CITY PLANNING COMMISSION

APPLICATION: A. Negative Declaration
B. Tentative Map (P84-426)

LOCATION: South terminus of Amherst Street at 18th Street

PROPOSAL: The applicant is requesting the necessary entitlement to subdivide 49+ vacant acres into 317 single family and halfplex lots.

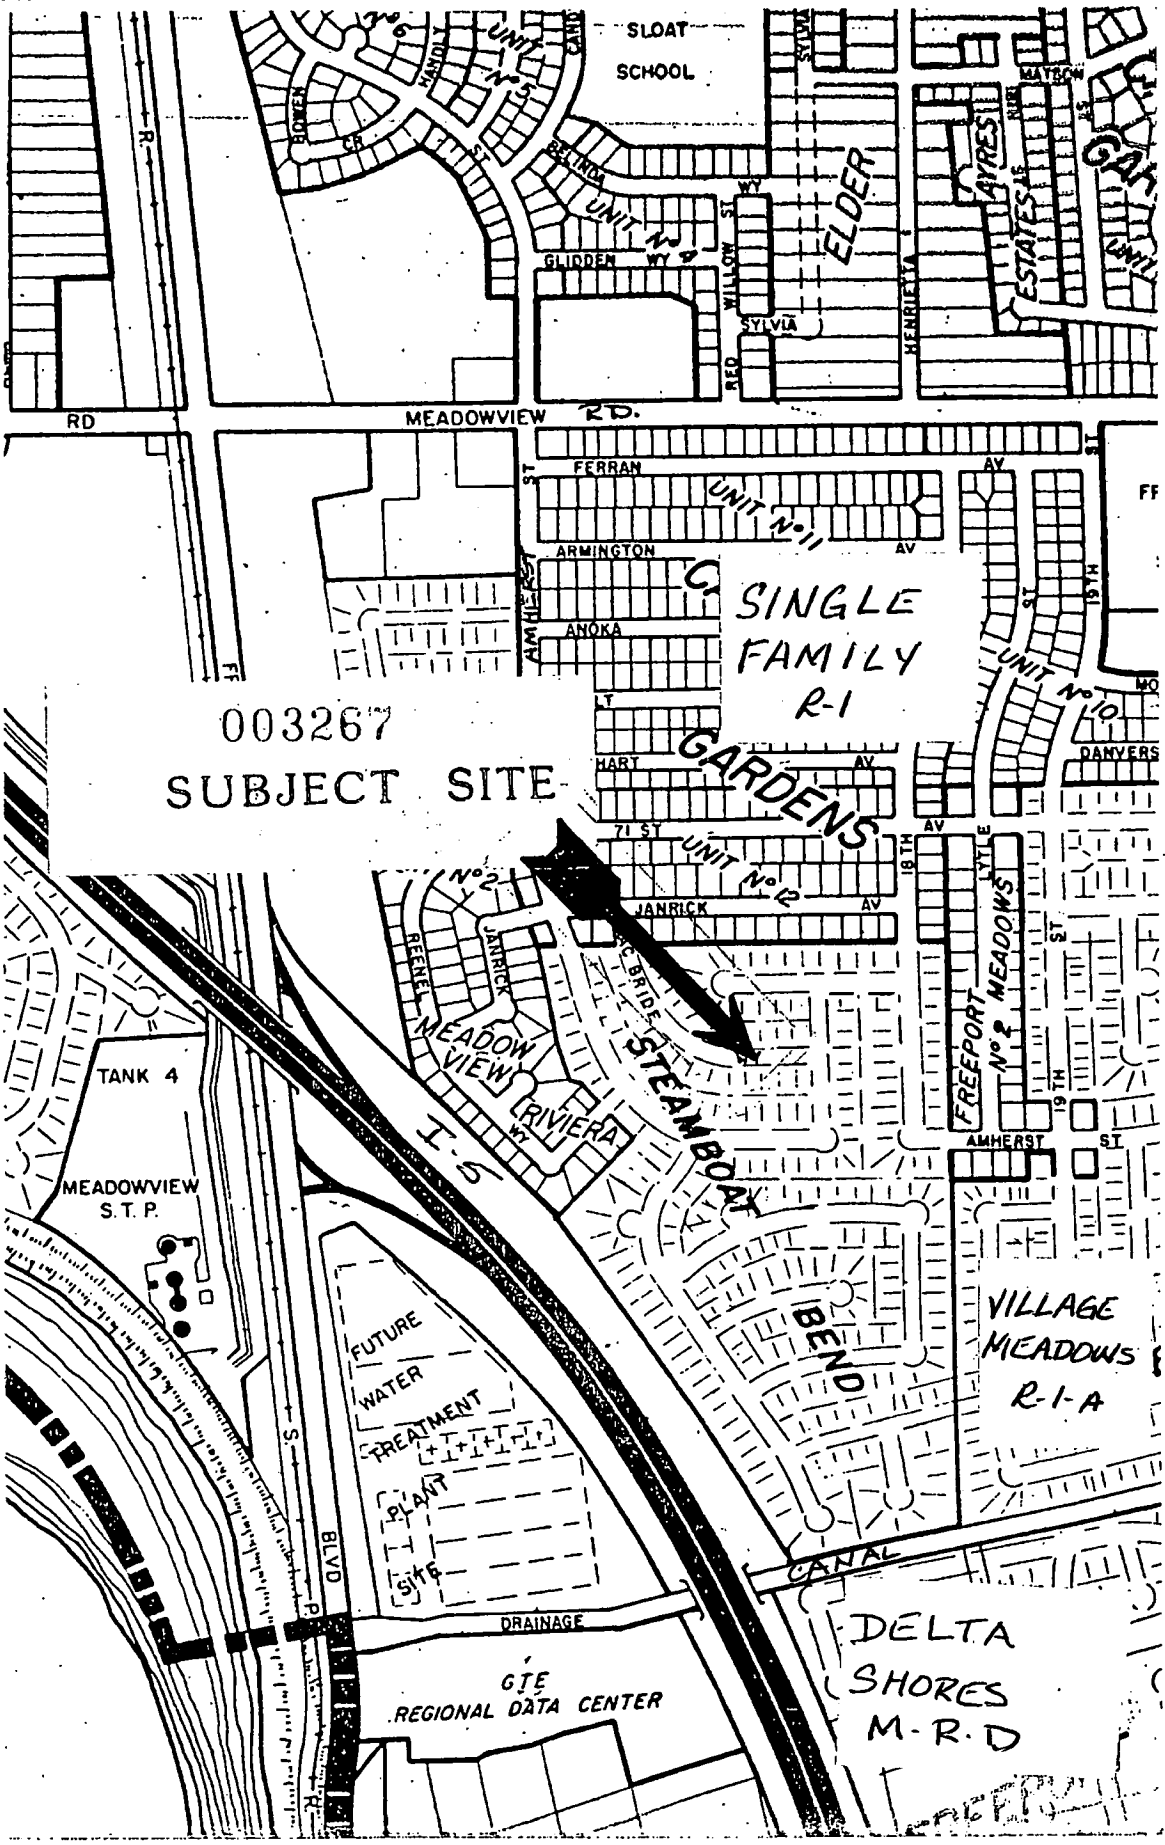
- B. The City Engineer requests that halfplex lots be consistently designated A and B. This clearly defines these lots for halfplex development.
- C. Special permit approval will be required when the applicant is prepared to develop the halfplex units. The following are design guidelines for halfplex development:

8. Provide connection between Amherst Street and loop street to the south at terminus of Amherst Street.
9. Provide channel lining and fencing for drain channel at south property line.

10. Provide a five-foot PUE along the eastern edge of Phase I.
11. Redesign the cul-de-sac mouth widths to the satisfaction of the City Traffic Engineer.

12. The unnamed street in Phases II and III, lots 1-16, shall have a 50-foot right-of-way.
13. The short unnamed street in Phase II, lots 75,76A,25,26, shall have a 50-foot right-of-way.

14. The unnamed street in Phase III, lots 23A-40, shall have a 50-foot right-of-way;
15. Renumber the subdivision so that halfplex lots are designated A and B.
